GLAST ENGINEERING CHANGE ORDER	Drawing No. GLT-LLR-00-10	Current Rev. G3	Outstanding ECO NONE	ECO No. 1

Drawing Title : **Close-Out Plate Y**

GLAST ENGINEERING CHANGE ORDER	Drawing No. GLT-LLR-00-10	Current Rev. G3	Outstanding ECO NONE	ECO No. 2

CLOSE OUT PLATE Y

a. Zone P-11

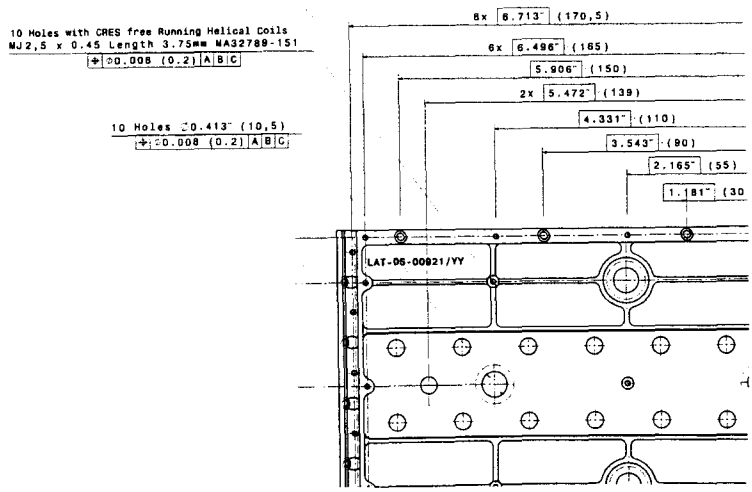
2. ADD NOTE FLAG AS SHOWN:

1. Was Condition (Section C-C, in Zone L-2):

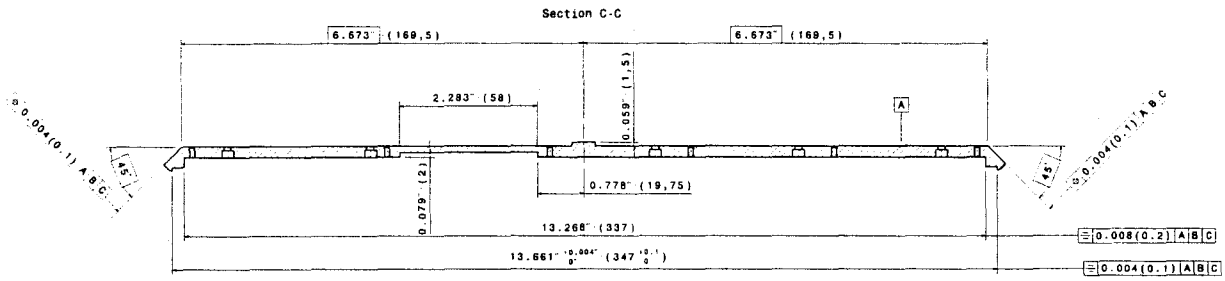
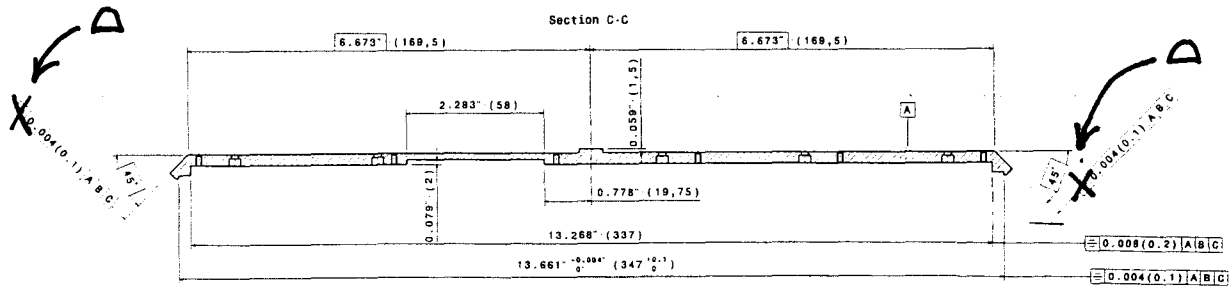
Reason : **Redefine Datum C to a feature which defines a clearer definition for the centerline of the part**

1. Now Condition (Section C-C, in Zone L-2) – Change Positional Tolerance to Profile Tolerance:

2. Was Condition (Section B-B, in Zone L-2):

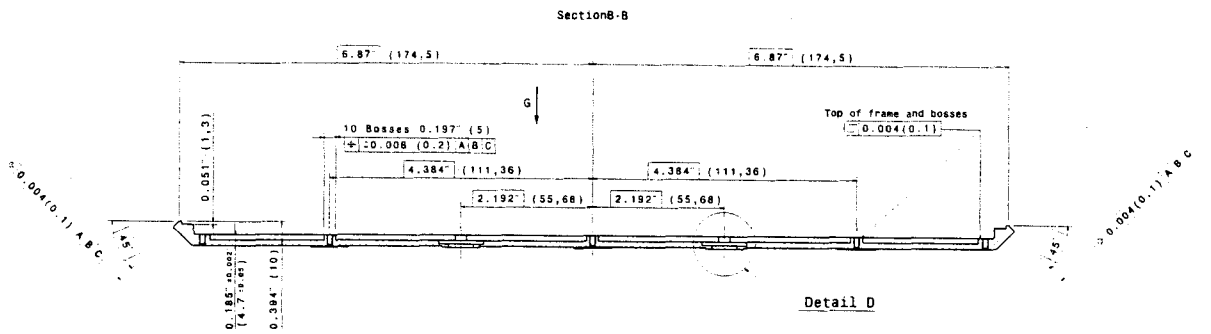
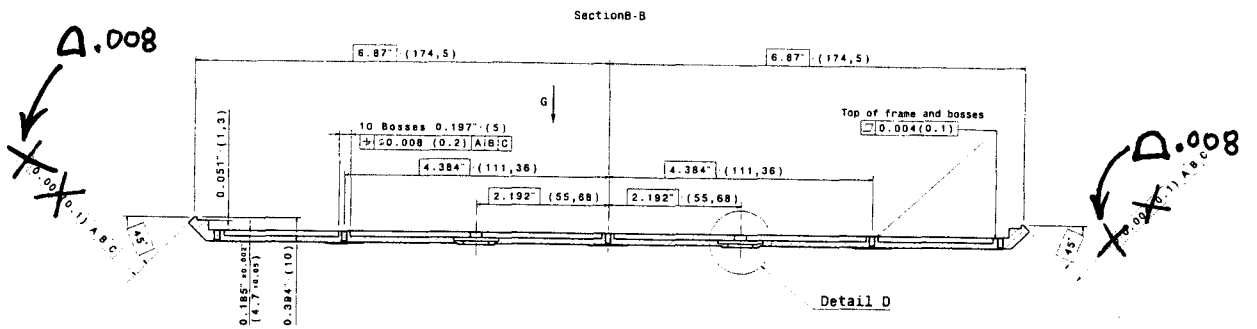
2. Now Condition (Section B-B, in Zone L-2) – Change Positional Tolerance to Profile Tolerance:

3. Was Condition (Zone D-8 and E-6):

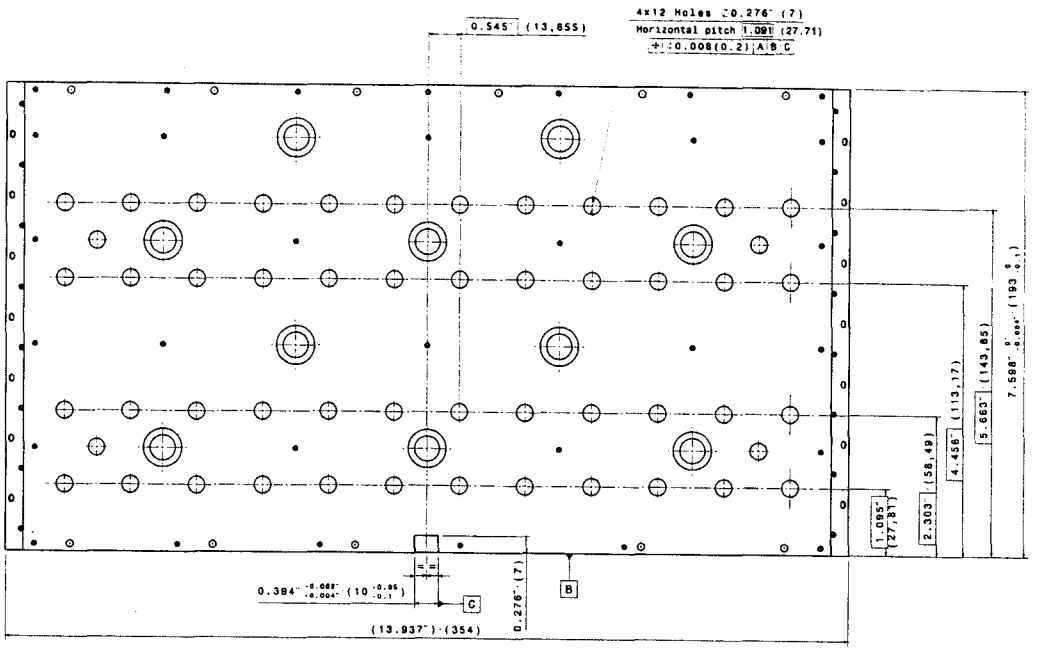
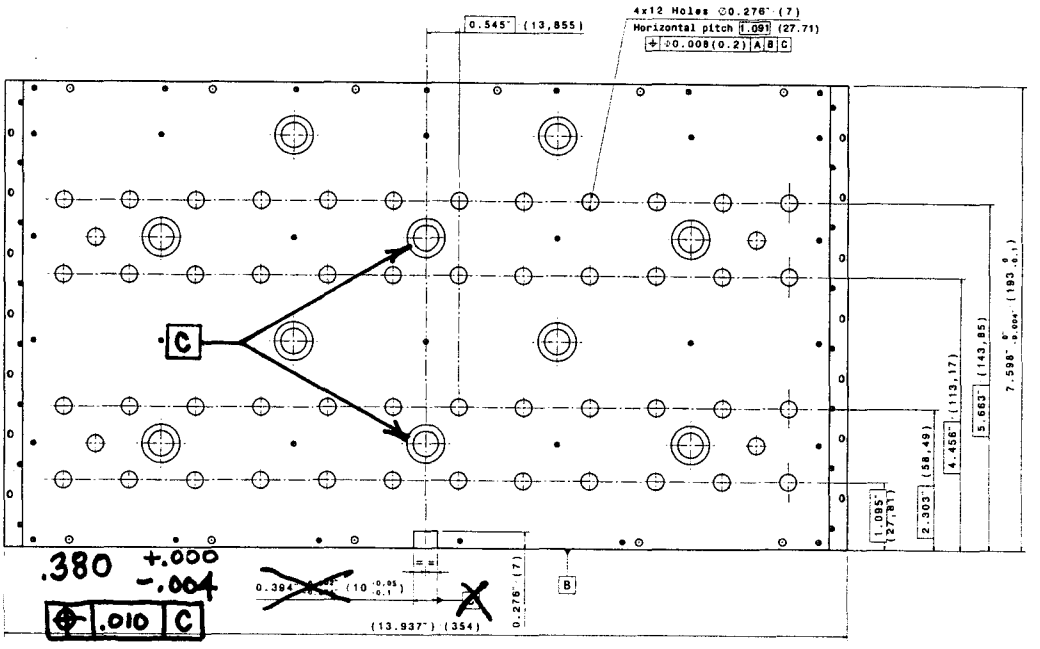
3. Now Condition (Zone D-8 and E-6):
